DATE: October 21, 2016

TO: SLDC Hearing Officer

FROM: John Lovato, Development Review Specialist Sr.

FILE REF.: CASE # V 16-5150 High Summit III (Phases 3-6)

REV DATE
NBA-27	
DESIGN ENGINEER	
<small>1401 LUNA STREET, SUITE C SANTA FE, NEW MEXICO 87505 (505) 991-1997</small>	
HIGH SUMMIT III - PHASE	
SLOPE ANALYSIS	
SCALE 1"=200'	DRAWN BY DHE

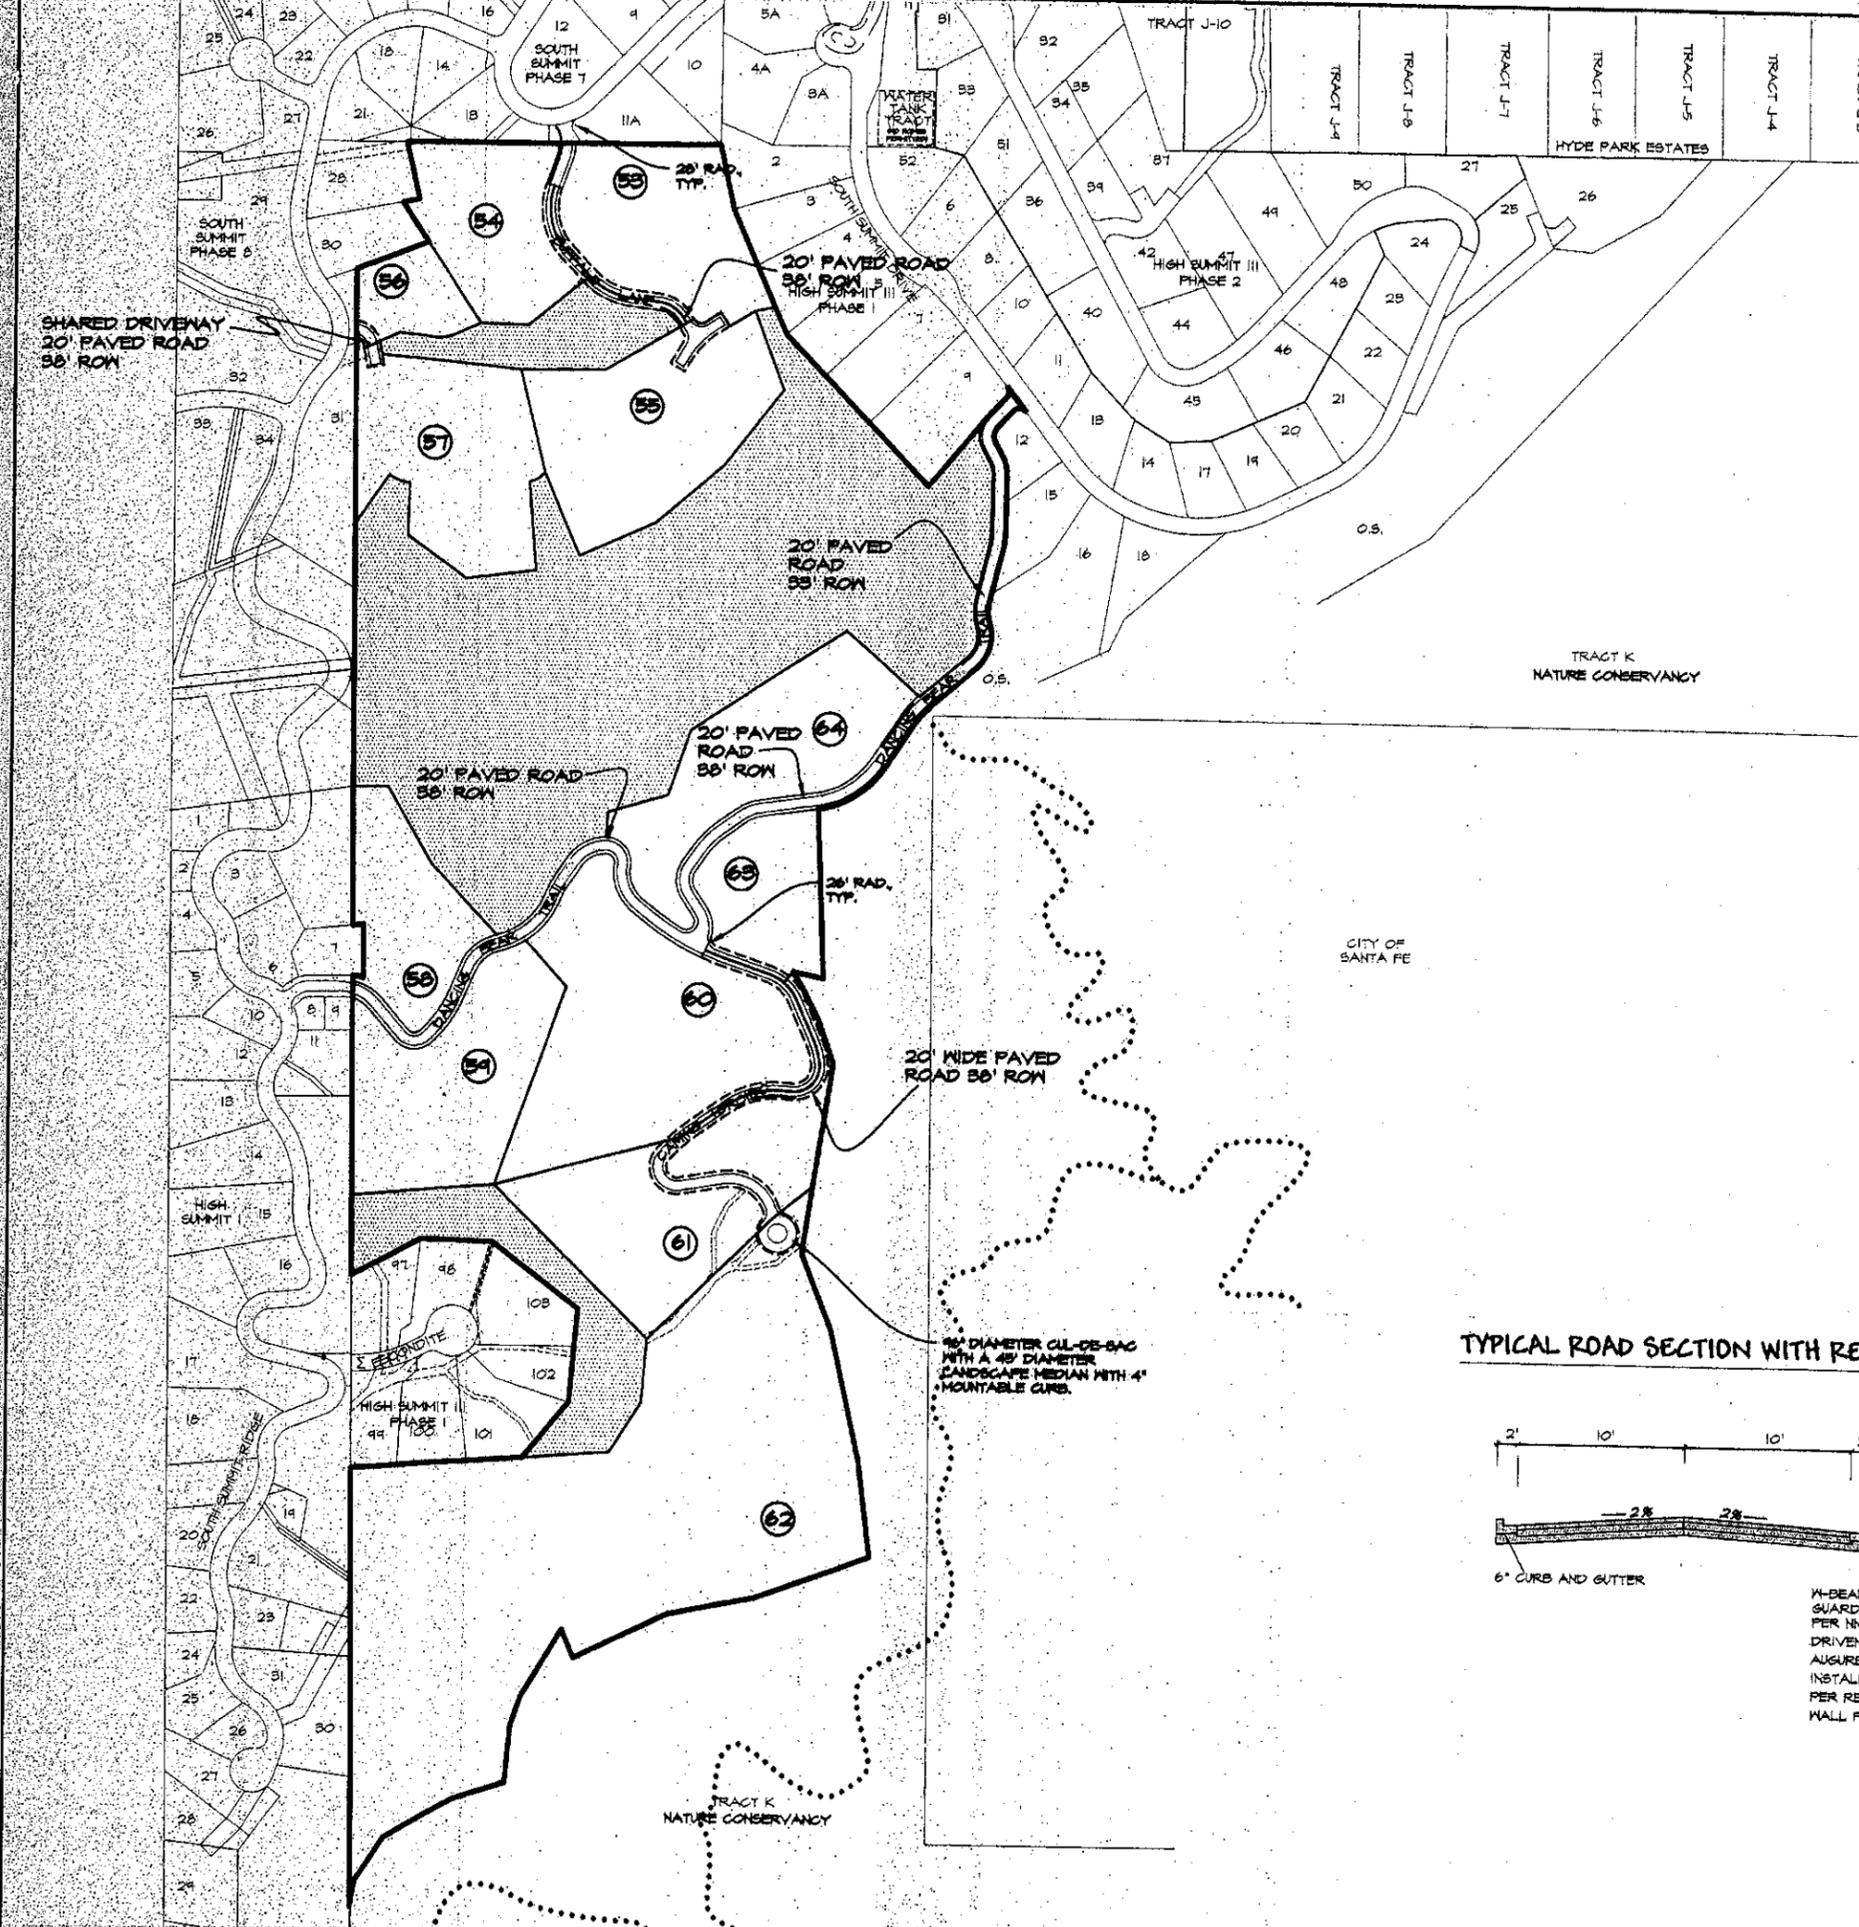
Staff Response: The Applicants are requesting additional slope disturbance for a total of 53,454 square feet. While homes will be reduced from 52 to 24 homes on the site, there is an increase of 3,289 square feet in slope disturbance.

Staff Response: Originally the Applicants requested 47,879 square feet of disturbance of 30% and greater. The proposed plans show a total of 50,165 square feet of 30 % or greater slope disturbance. However, the Applicants would like an additional 3289 square feet of additional slope disturbance for a total of 53,454 square feet. While homes will be cut in half from 52 to 24 homes on the site, there is an increase of 3,289 square footage in slope disturbance This increase will be visible from lower locations in the surrounding community.

DANCING BEAR TRAIL

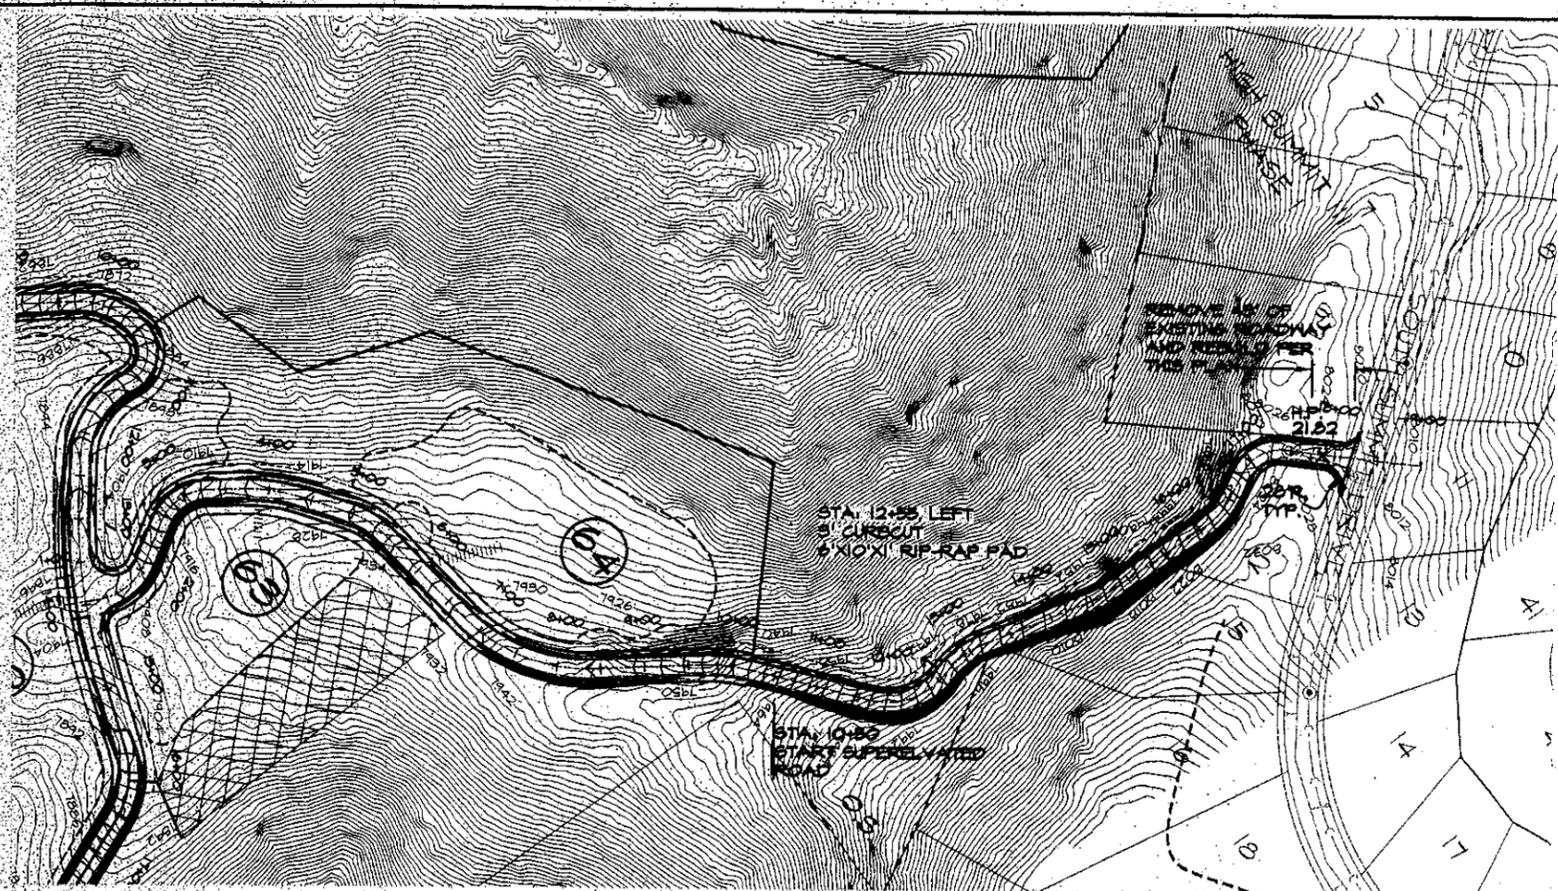
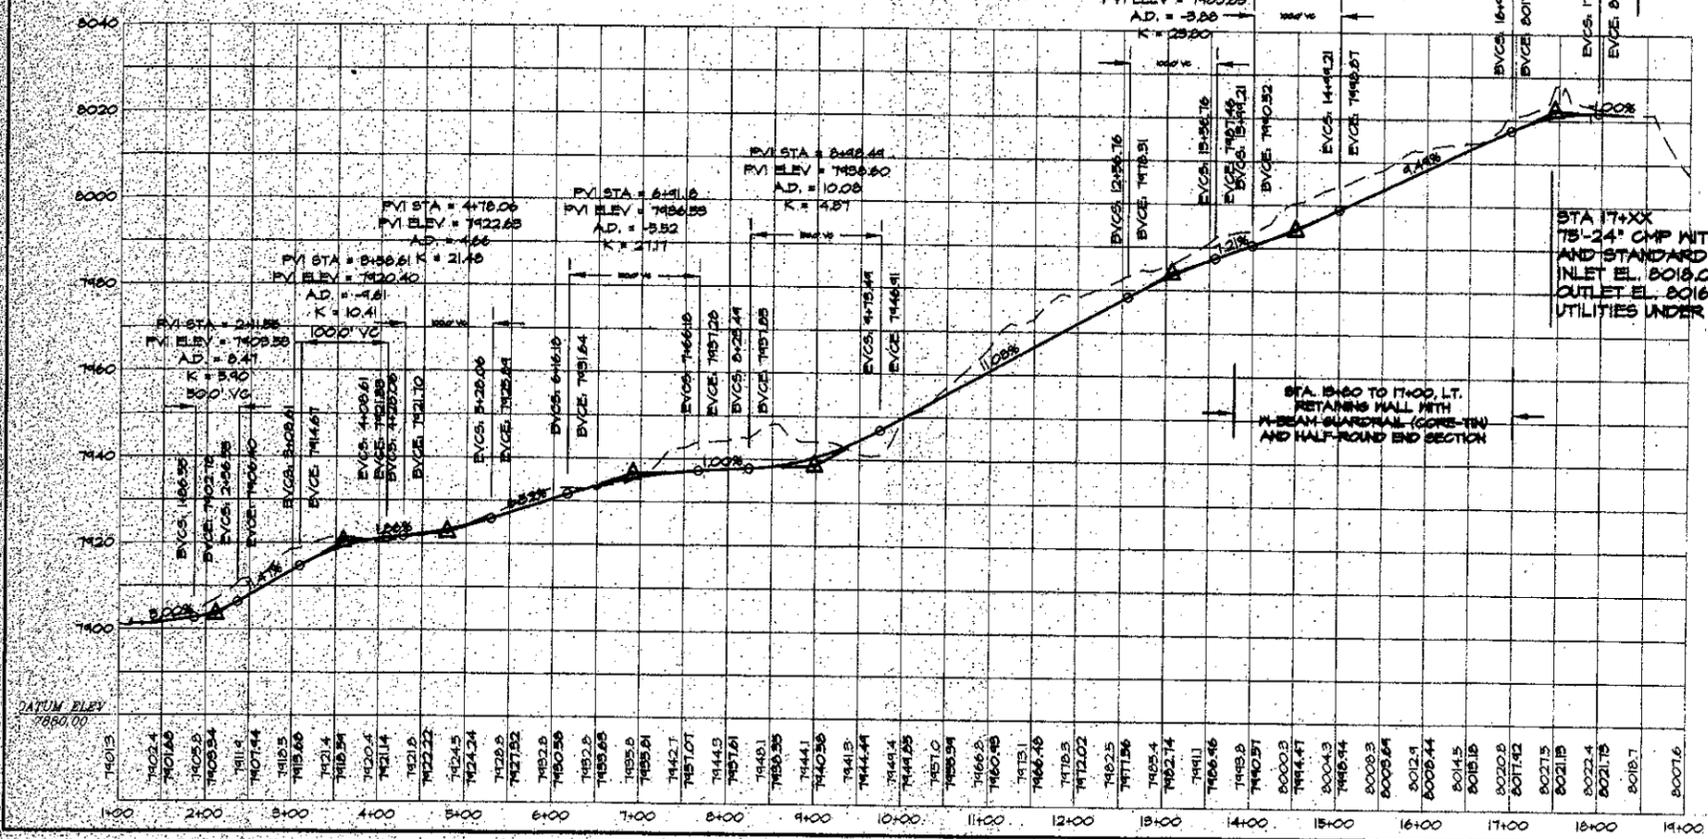
Victoria DeVargas, asked if the road could be paved to ensure that it was properly maintained and she wanted 20' wide pull outs to allow traffic passing. Upon review of the issue, it was decided that for safety reason and optimal traffic circulation, this paved road should not be gated and should be designed for 2-way traffic for its entire length, rather than just emergency traffic. Widening the road will disturb more 30% slopes. This modification necessitates the following variance.

Staff Response: The prior approval allowed the Applicant to build Cuesta Brava to 15' in width and be used for emergency access only. The request for the variance for additional slope disturbance of Dancing Bear Trail (Cuesta Brava) is due to the Applicant proposing to widen the road and make it a through road that would provide an additional point of ingress and egress through the subdivision for the residents as well as for emergency vehicles.

BUFFALO LANE

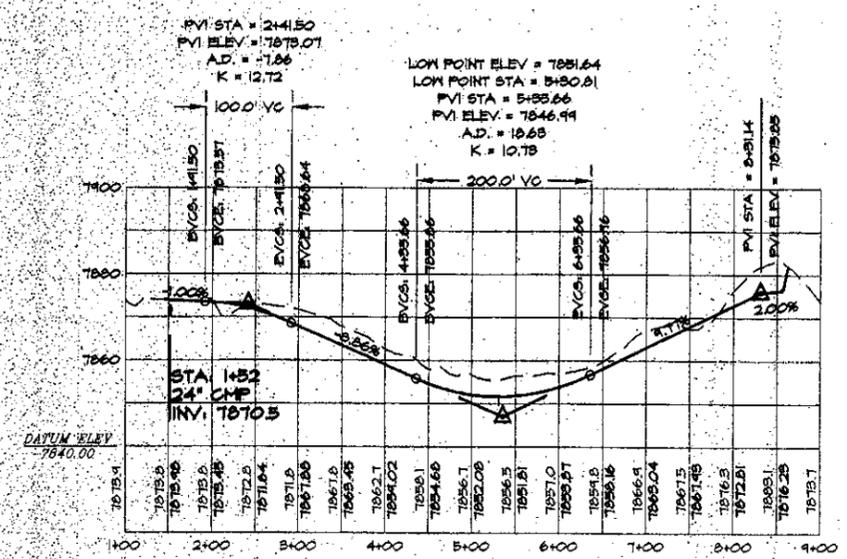
By eliminating much of the planned Buffalo Lane (previously called Calle Juanita) roadway, the project will disturb less terrain, but per code it is necessary to install a Fire Marshal approved turnaround at the end of the road. We have selected a site for this turnaround that is not visible to existing public roads.

Staff Response: The Applicants would like an additional 3289 square feet of slope disturbance for a total of 53,454 square feet. While the number of homes in phases 3-6 will be reduced from 52 to 24 homes, there is an increase of 3,289 square footage in slope disturbance. This increase will be visible from lower locations in the surrounding community. The Applicant is proposing pedestrian trails throughout the development, however a 1 acre developed park is required. Although the terrain is difficult in most areas and the Applicant is wanting to avoid significant slope disturbance it may be feasible for the Applicant to install some of picnic shelters and benches around the trails with minimal disturbance to satisfy this requirement. Under the previous regulations by which this subdivision was approved, roads and driveways were allowed to go up to 11%. The request is for road and driveway grades up to 11.6%. A requirement for sidewalks would result in additional disturbance, and if they cannot be constructed to ADA standards this would pose a safety issue.
